Minor Variance Application

A052/20

Property: 456 Westridge Dr Kleinburg

Purpose: Relief from By-law 1-88, as amended, is being requested to permit the construction of a proposed cabana located in the rear yard.

SHEET TITLE:	
SITE PLAN, KEY PLAN, SITE STATISTICS

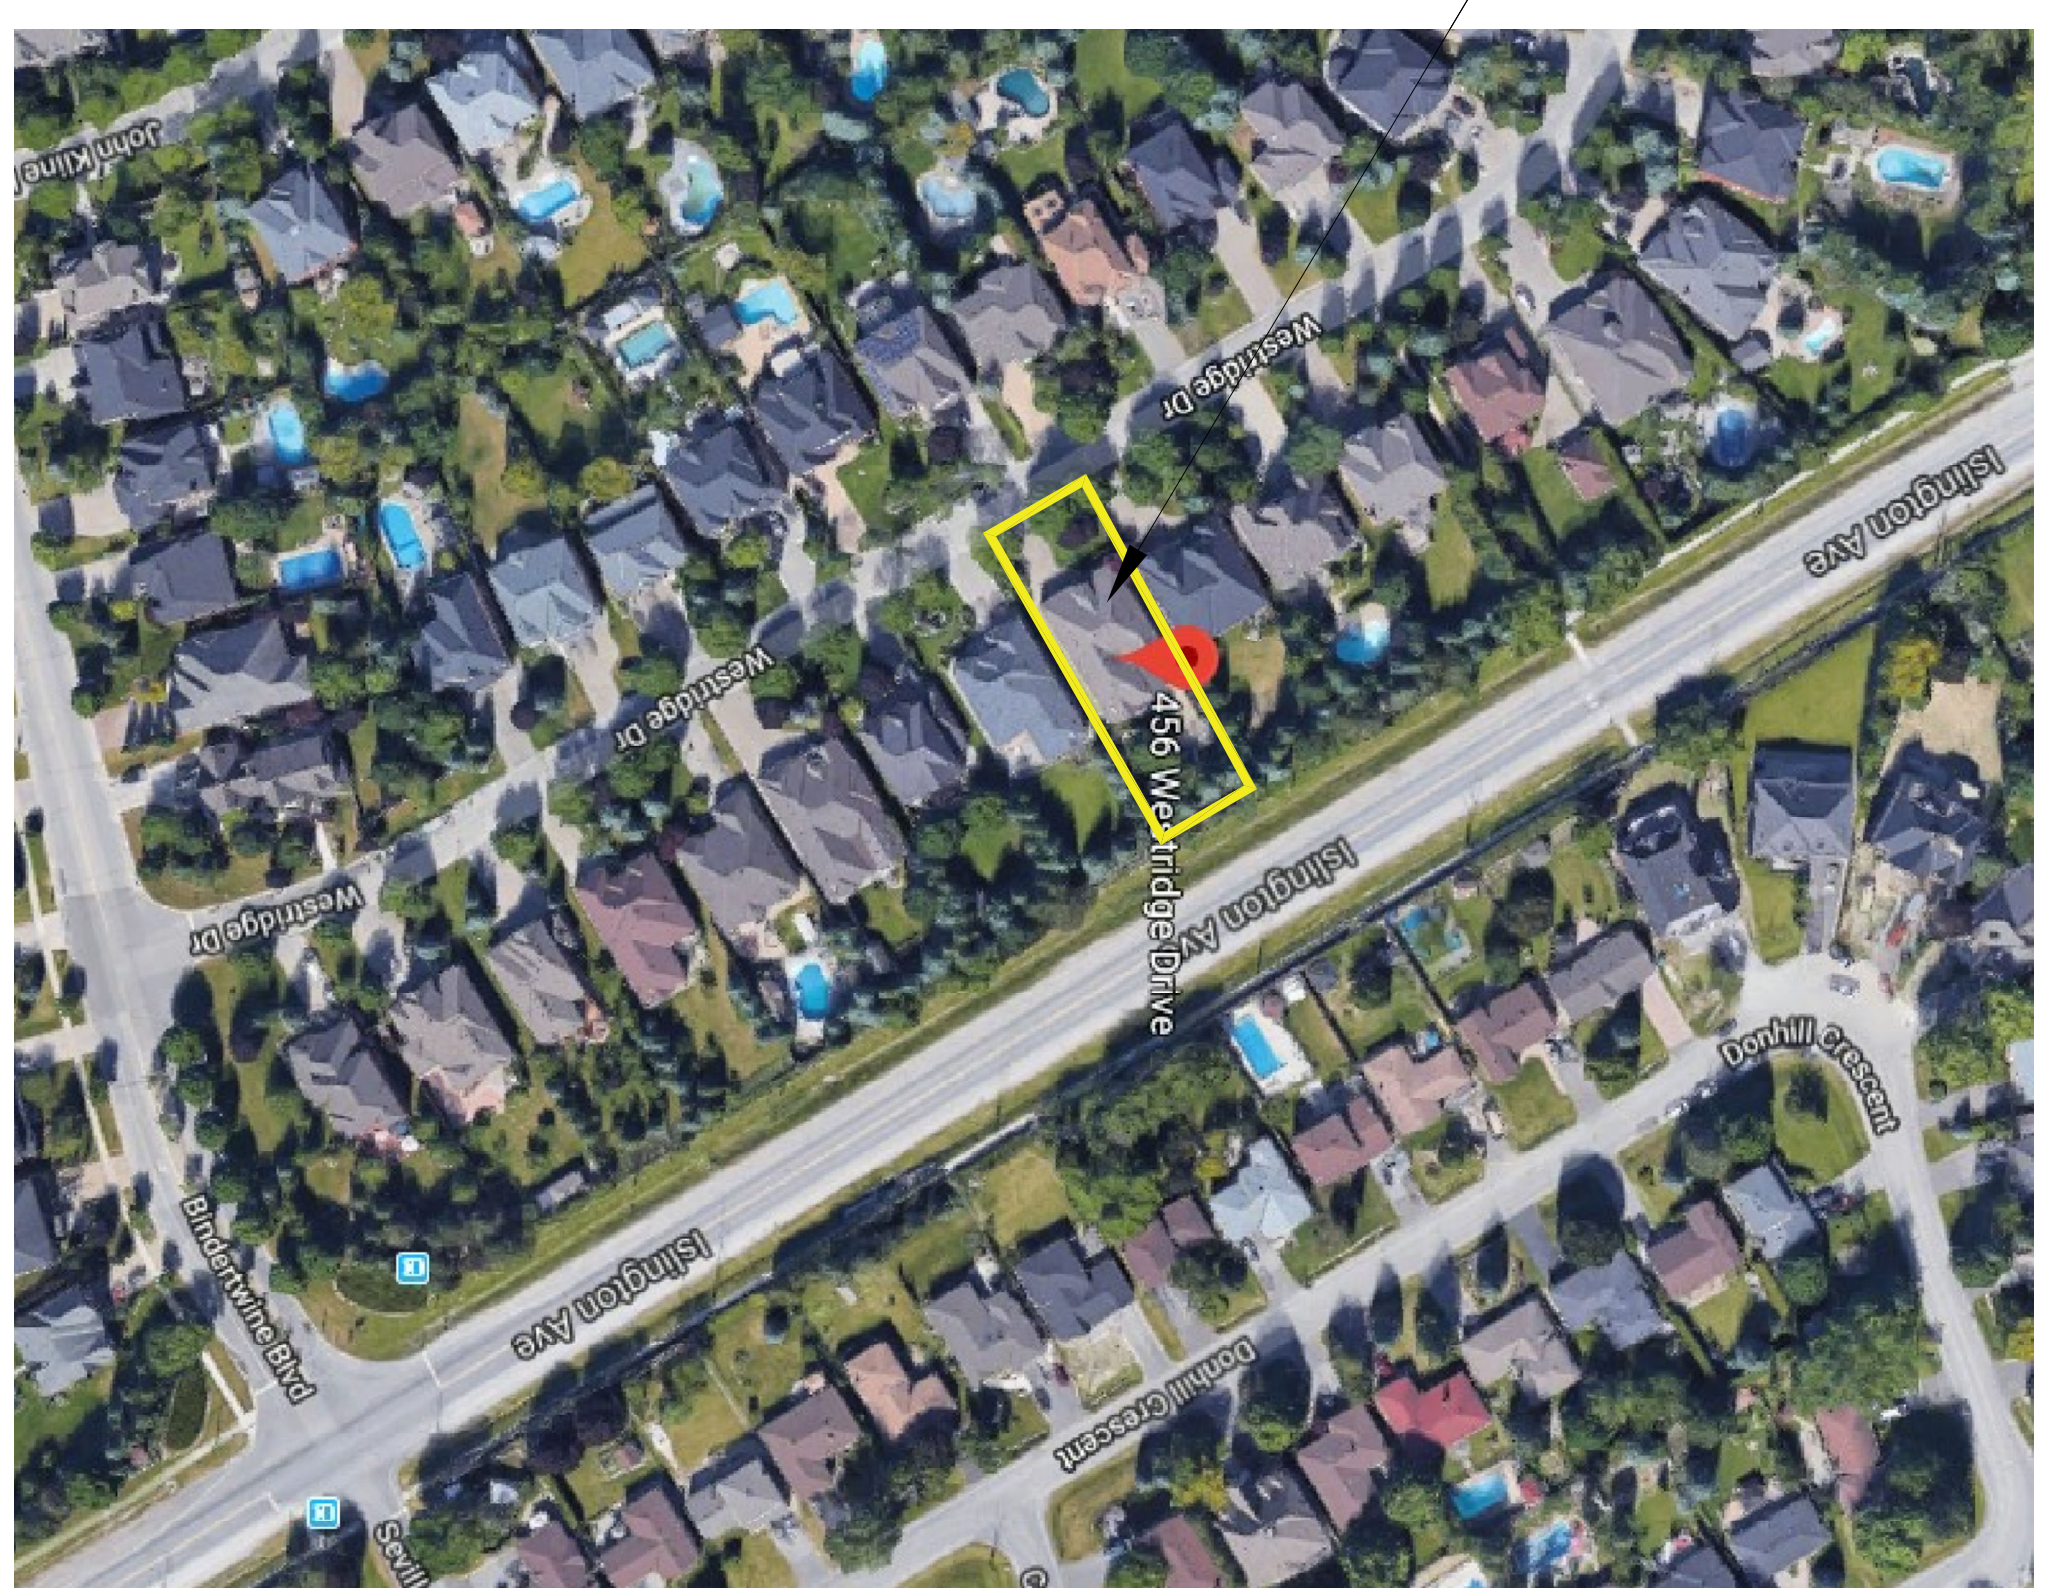
Development Planning Department staff have requested that the proposed cabana be pushed further away from the rear lot line to retain adequate screening in an effort to preserve the interface with Islington Avenue and to potentially save trees by improving the cabana's interior side yard setback. These comments were provided to the Agent on July 24th, 2020, including a request for a Tree Inventory, Preservation and Replanting Plan.

As such, the Development Planning Department recommends that the application be **adjourned** until such a time that revisions are made to the proposed cabana location and that the Tree Inventory, Tree Preservation and Replanting Plans are approved to the satisfaction of the Urban Design and Cultural Heritage Division.

SHEET TITLE: Floor layout

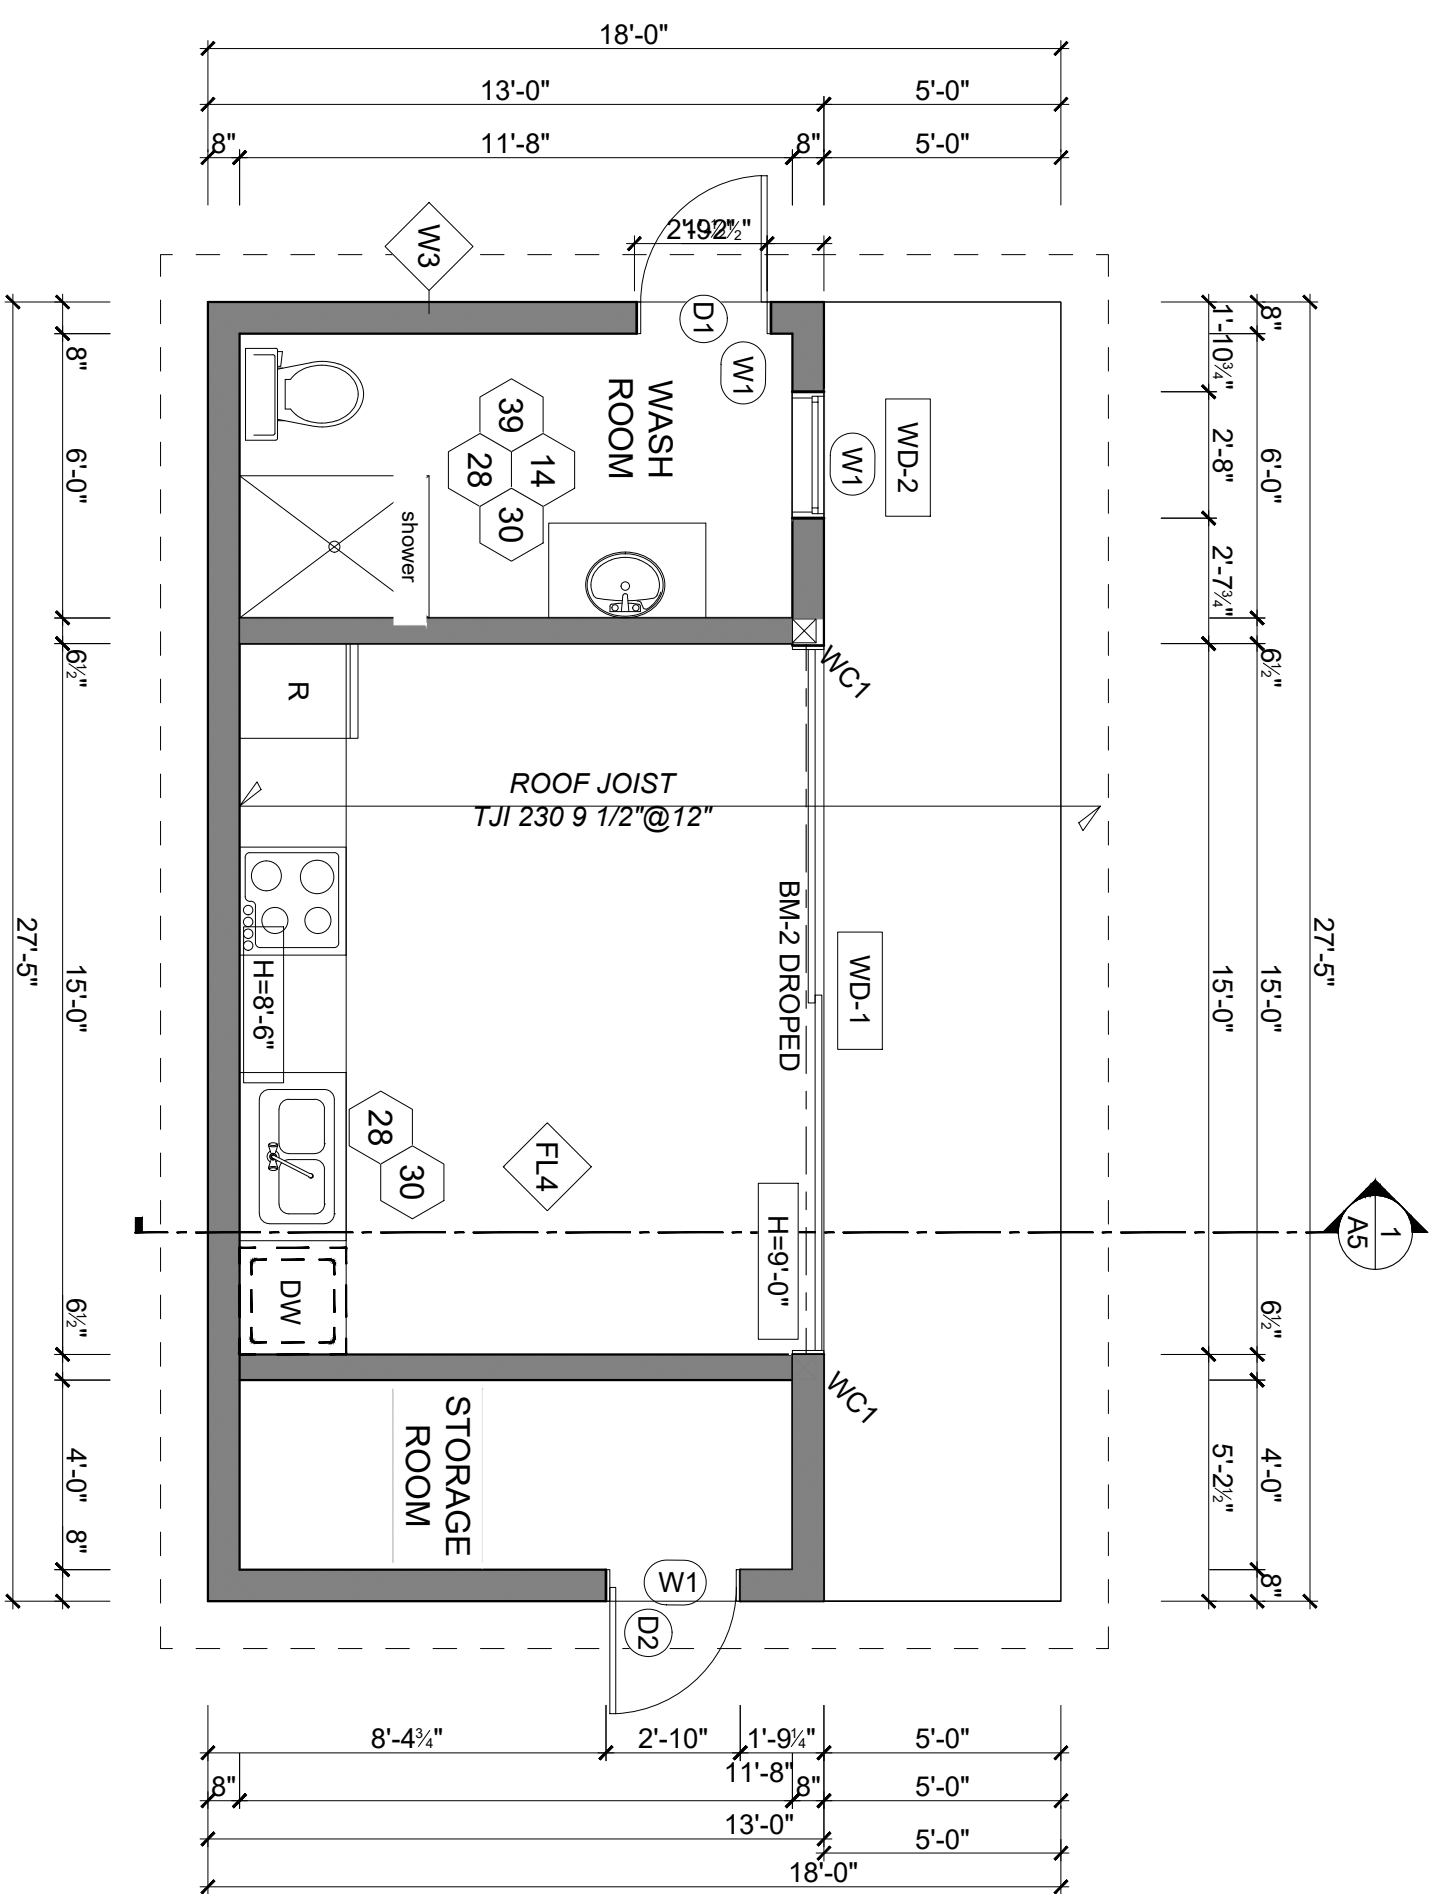
Please note the Stove indicated on the drawings shall be removed, as it would thus constituted a dwelling unit and only one dwelling unit is permitted on this lot. The accessory structure shall not be used for human habitation.

SHEET TITLE: Elevations
DRAWING NO. A-3

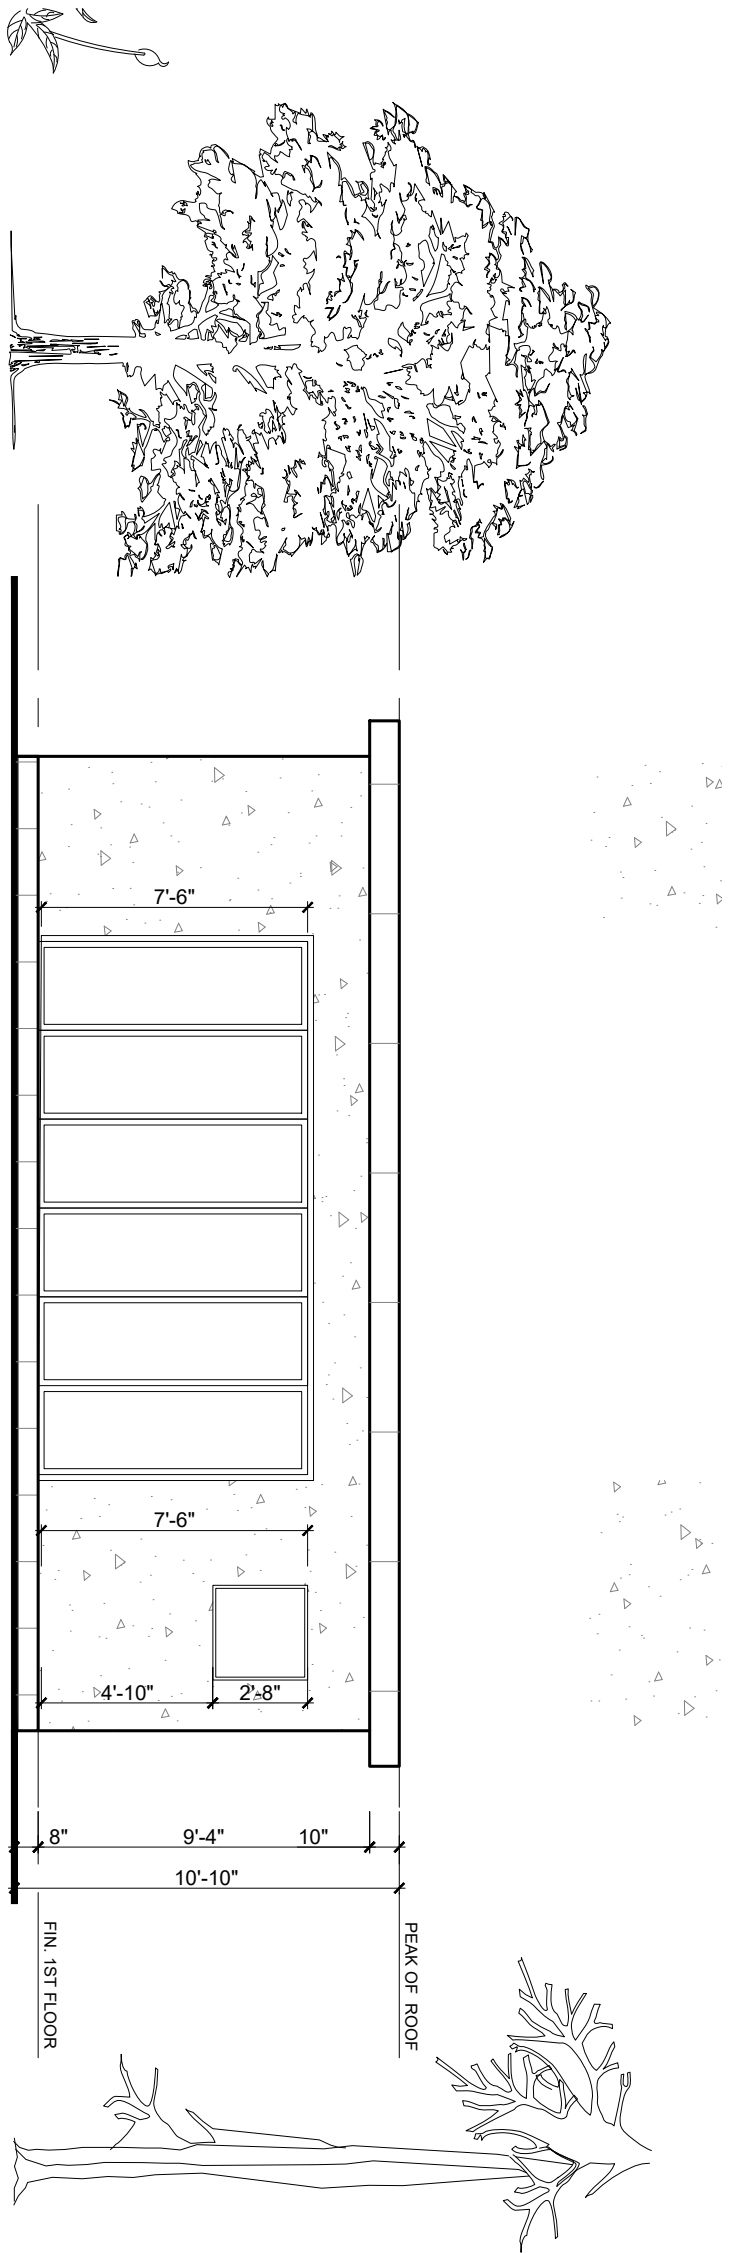
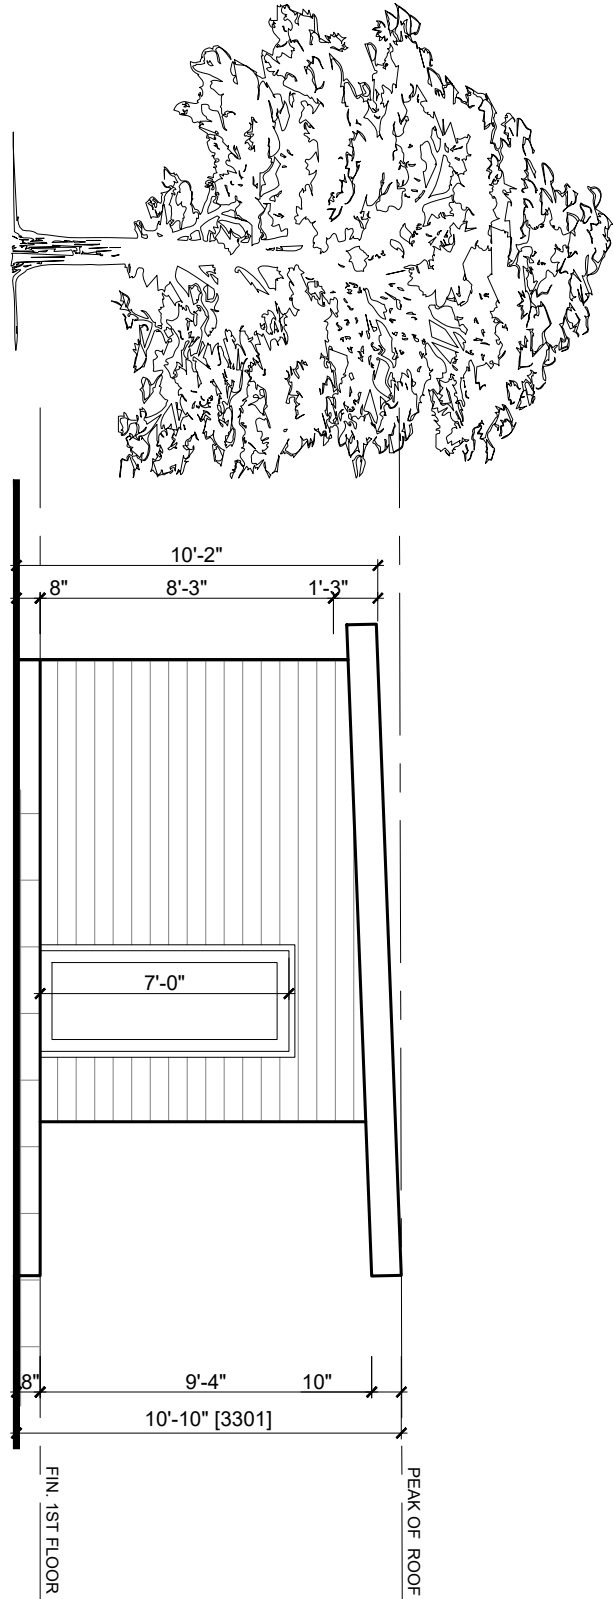
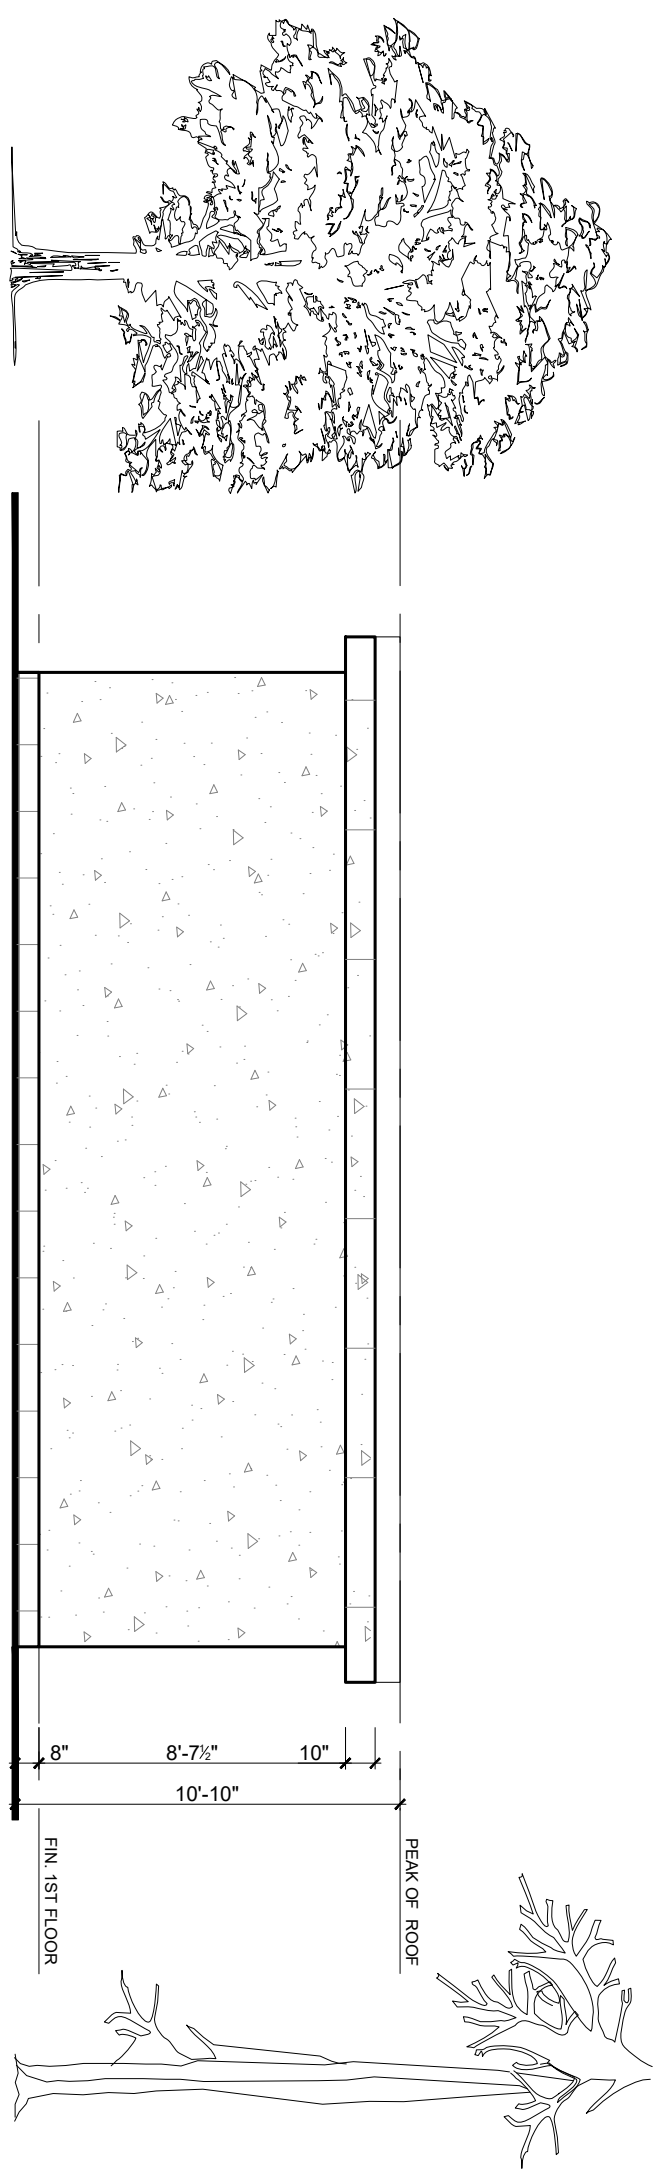
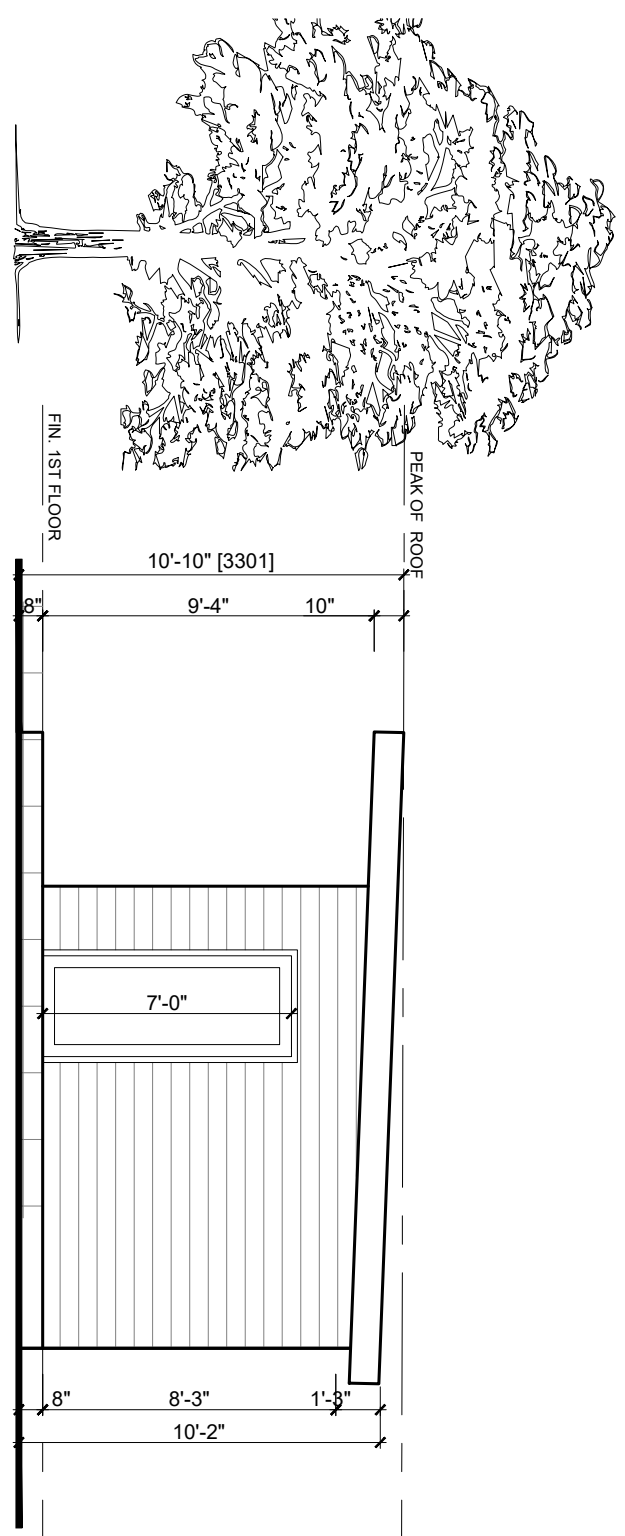
Please note Section 4.1.1(b) that states the maximum height of an accessory building or structure measured from the average finished ground level to the highest point of the said building or structure shall be 4.5 metres. The nearest part of the roof shall not be more than three(3) metres above finished grade.
